Office Action Summary

10/763,292

MURAMATSU ET AL.

DETAILED ACTION

FIG. 3A

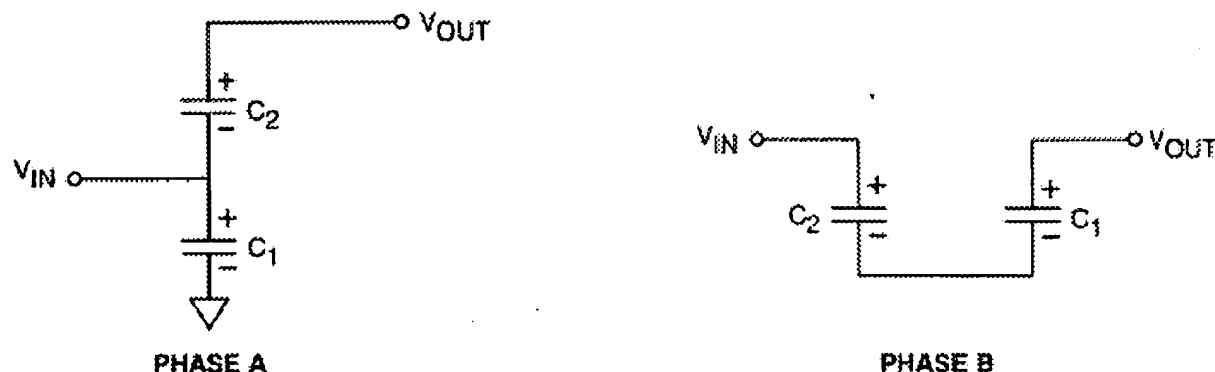
4. Claims 1-4, 18 and 19 are rejected under 35 U.S.C. 102(b) as being clearly anticipated by Rader et al. (USP 6,504,422). Rader discloses the claimed connection of applicant's claims see below 3A. The exact same figures as applicant's figure 1a and 1b. For claim 18, the current control circuit see figure 6.
